Technical Service Bulletin

74 Seat pneumatics system activates without driver input

74 14 17 2035757/2 February 21, 2014. Supersedes Technical Service Bulletin Group 74 number 13-15 dated November 15, 2013 for reasons listed below.

Figure 2. Example of DTC set for the control module after SVM code is performed.

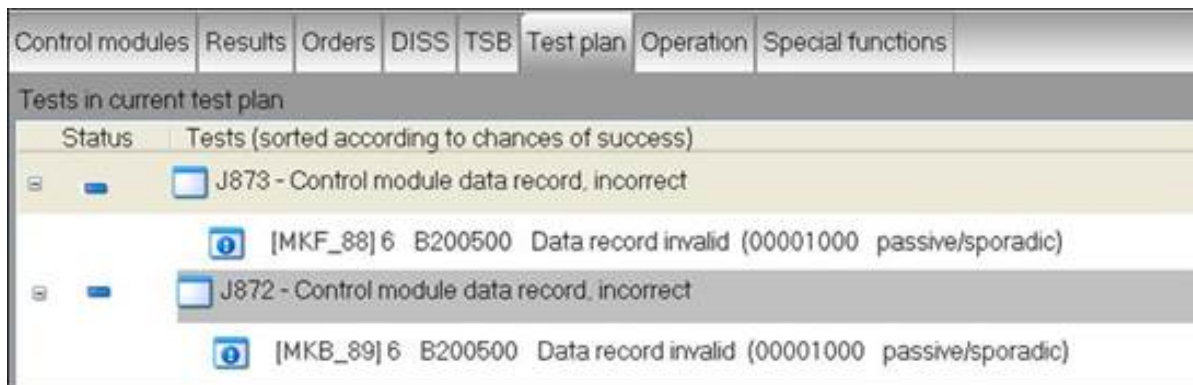
2. After the SVM code is performed, one DTC will be set for each control module (Figure 2). Clear the DTCs before finalizing the procedure.
